**CITY OF CHESTERFIELD
PLANNING AND PUBLIC WORKS COMMITTEE MEETING**

**THURSDAY, APRIL 23, 2026
5:30 P.M.**

RE: Carshield: An Amended Site Development Plan for a 32-acre tract of land zoned "PI" Planned Industrial located east of N. Eatherton Rd.

RE: **Westland Acres 2026 SDP:** A Site Development Plan and Landscape Plan for 56.31 acres of land zoned “PUD” Planned Unit District located north of Strecker Road and east of Church Road.

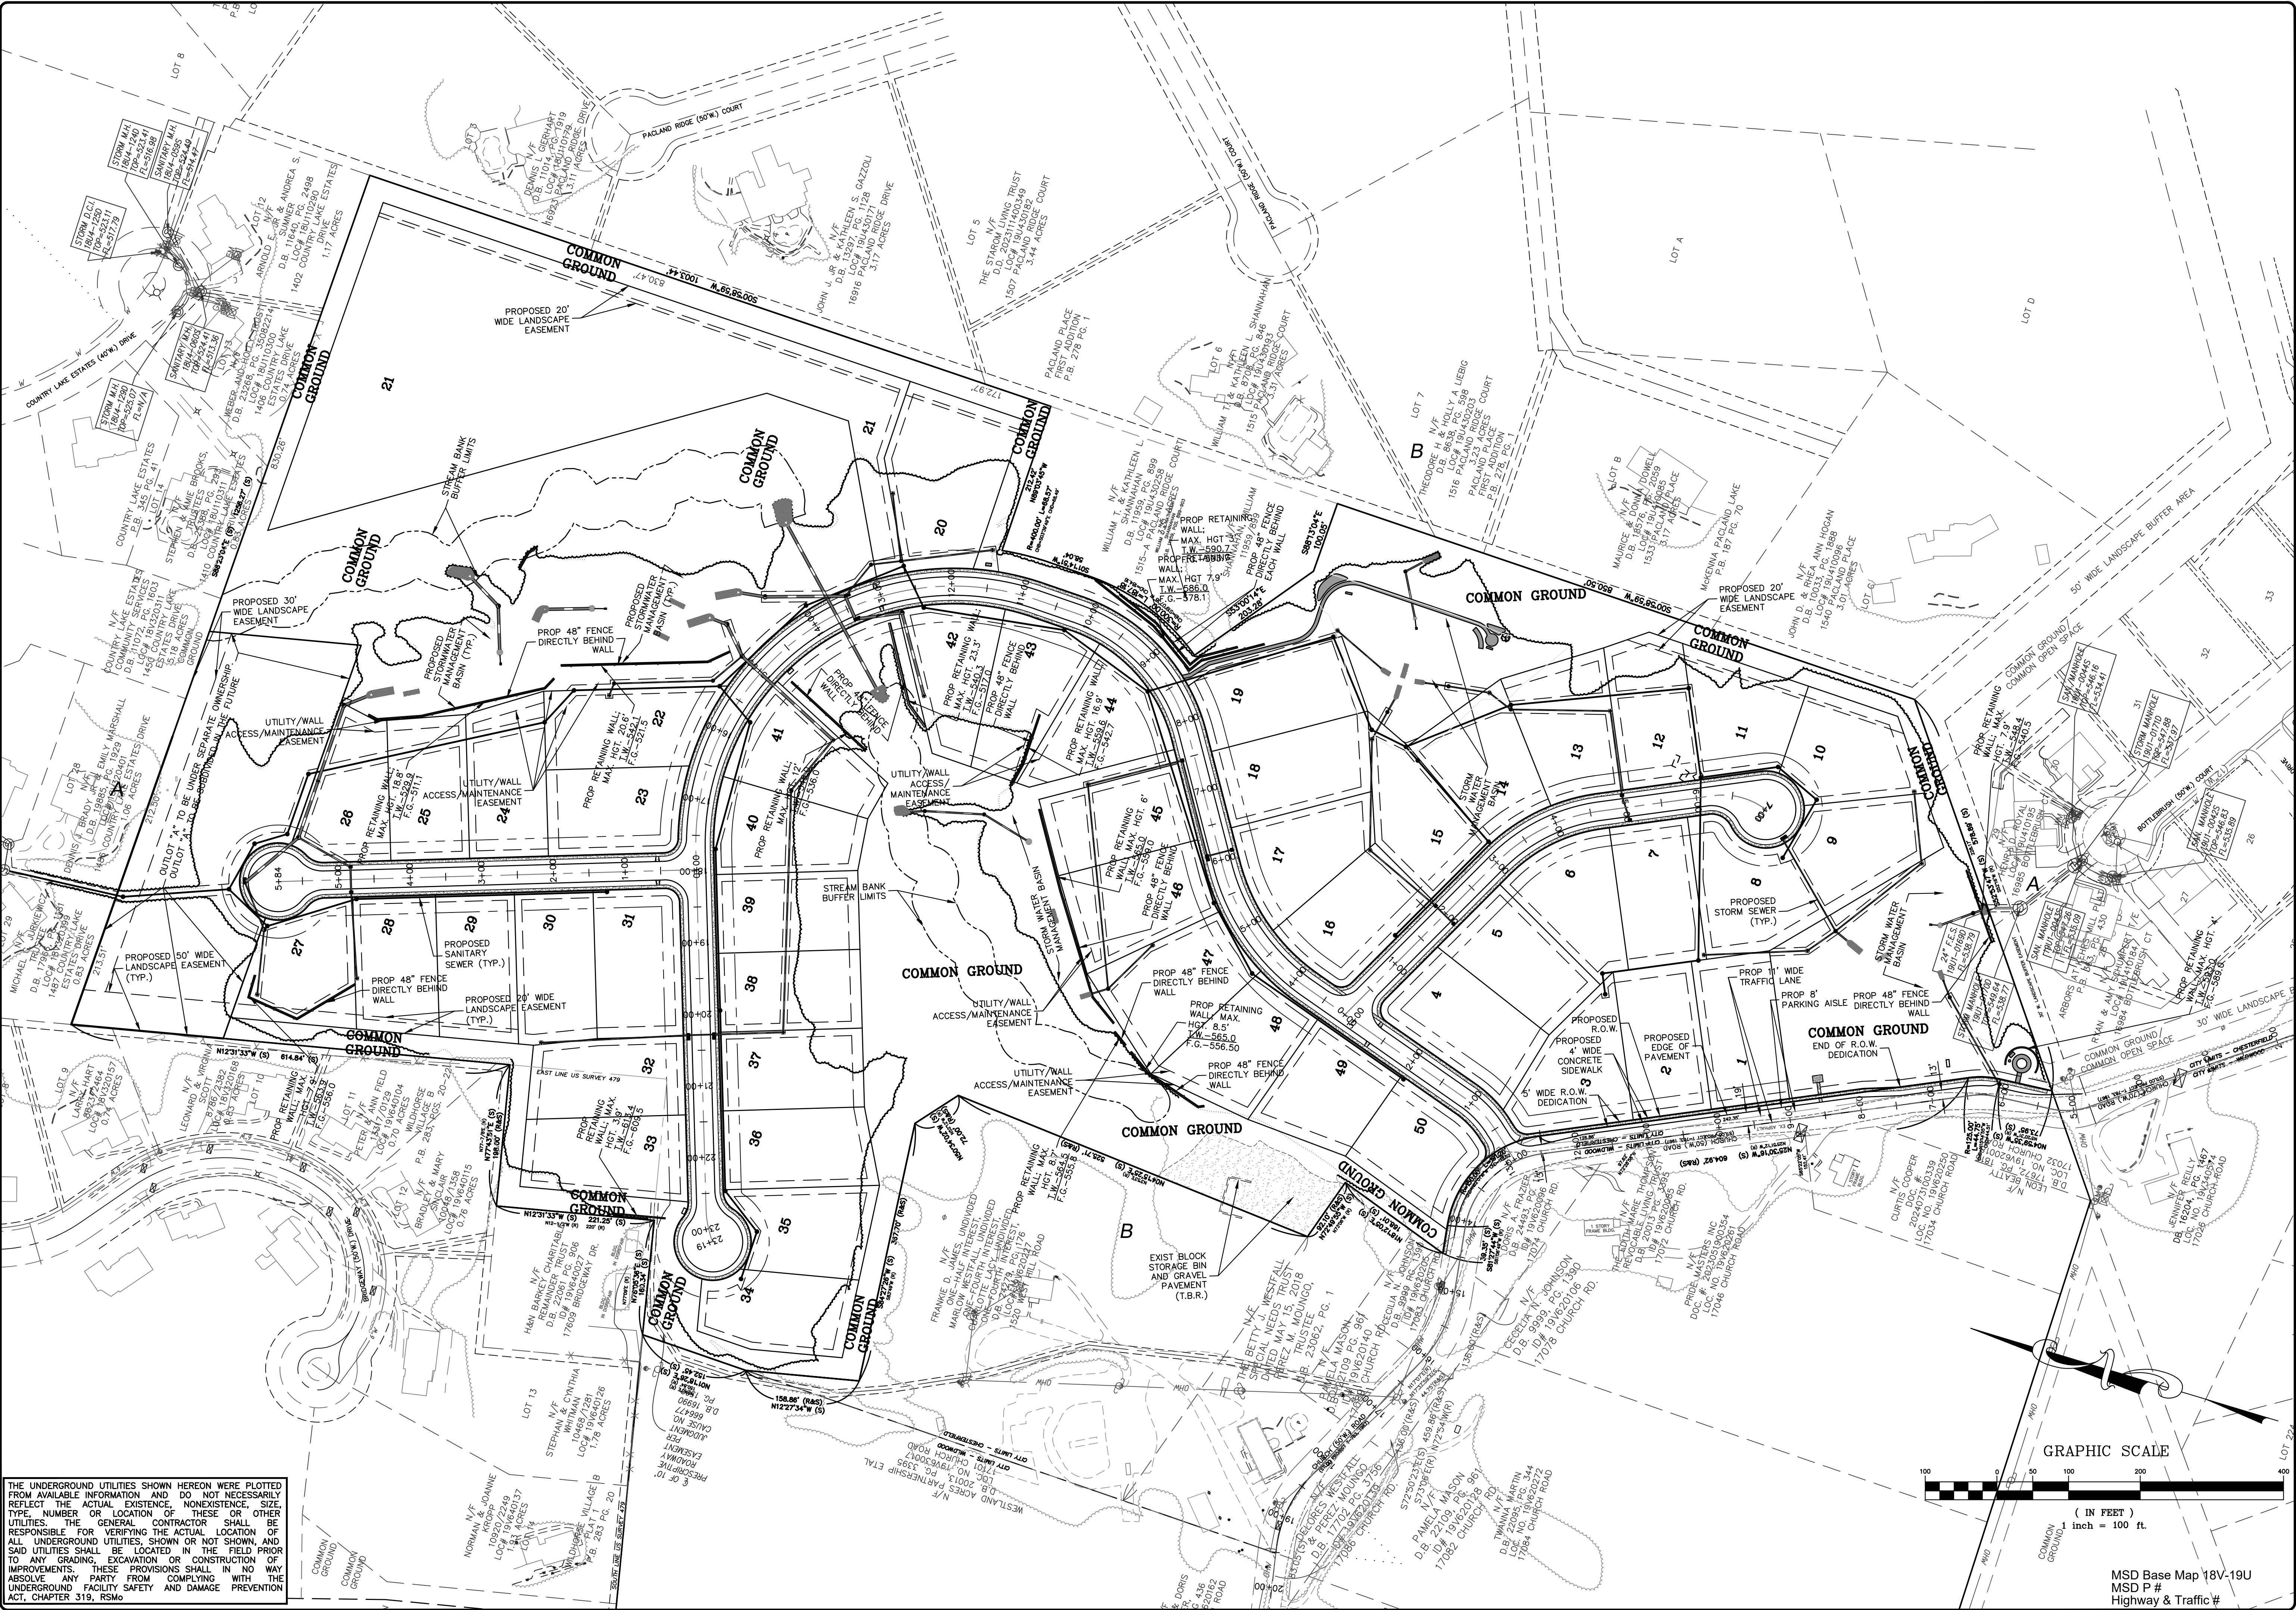
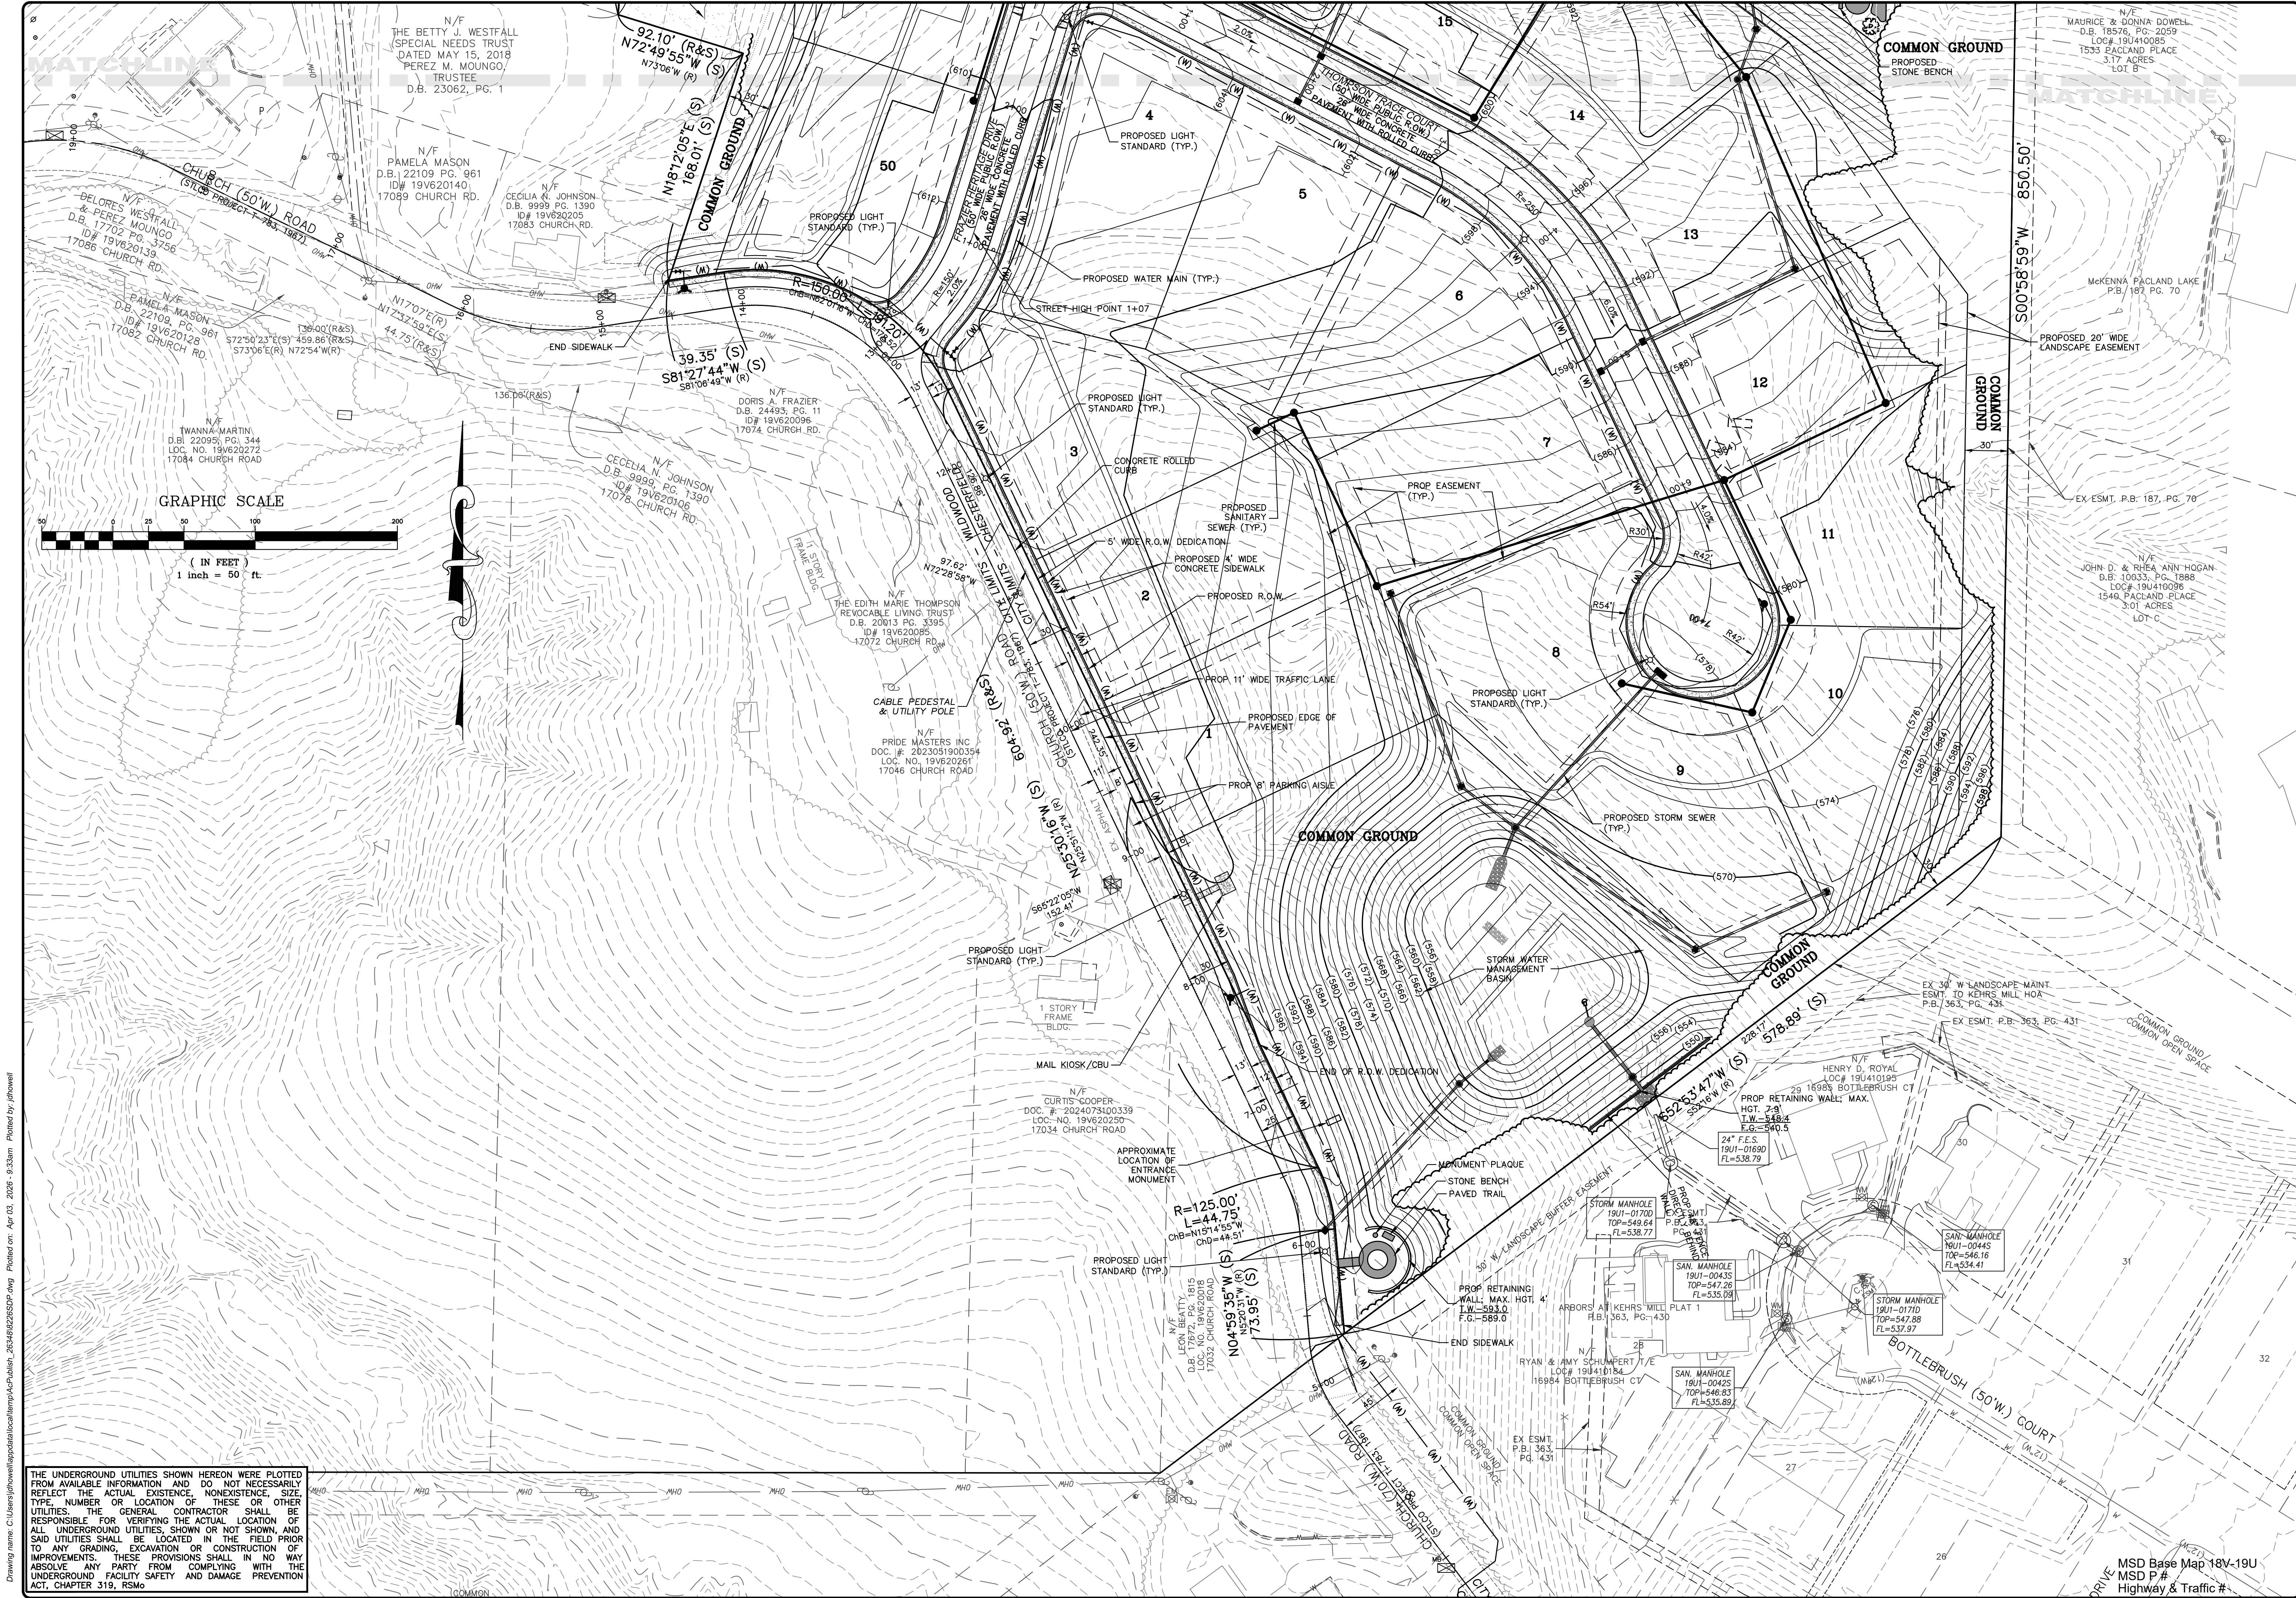
- The narrative and cost estimates do not align with the request to provide information on the cost difference between a 26-foot and a 33-foot wide roadway.

- We (Department of Public Works) have reviewed the cost estimates, and nothing stands out as out of line on a unit cost basis. But the fact that costs for the plan including two roads is higher in costs for storm sewer (\$251,655), water (\$250,469) and management fee (\$74,000) is not caused by increased pavement width. This cost increase of \$576,124 cannot be attributed to a wider road. It is attributable to a completely revised layout.

- The only costs that can be considered as direct costs for the wider road (as staff understands the direction from the Mayor and Councilmembers on P&PW) are the street costs and the earthwork / retaining wall costs. Those costs are higher in the plan with two roadways by \$295,000 and \$528,209 for a total cost of \$823,902. But not all of the street costs are attributable to the revised width. Some – likely most – are attributable to the revised layout and the fact that there are now two roads traveling north/south on most of the project.

- For the applicant to justify additional costs (as requested by P&PW and the Mayor) for the wider road in the plan with two roadway is for the applicant to provide another cost estimate that shows the costs of the layout with a narrower road. Then those costs can be compared to accurately reflect the true cost of the wider road.
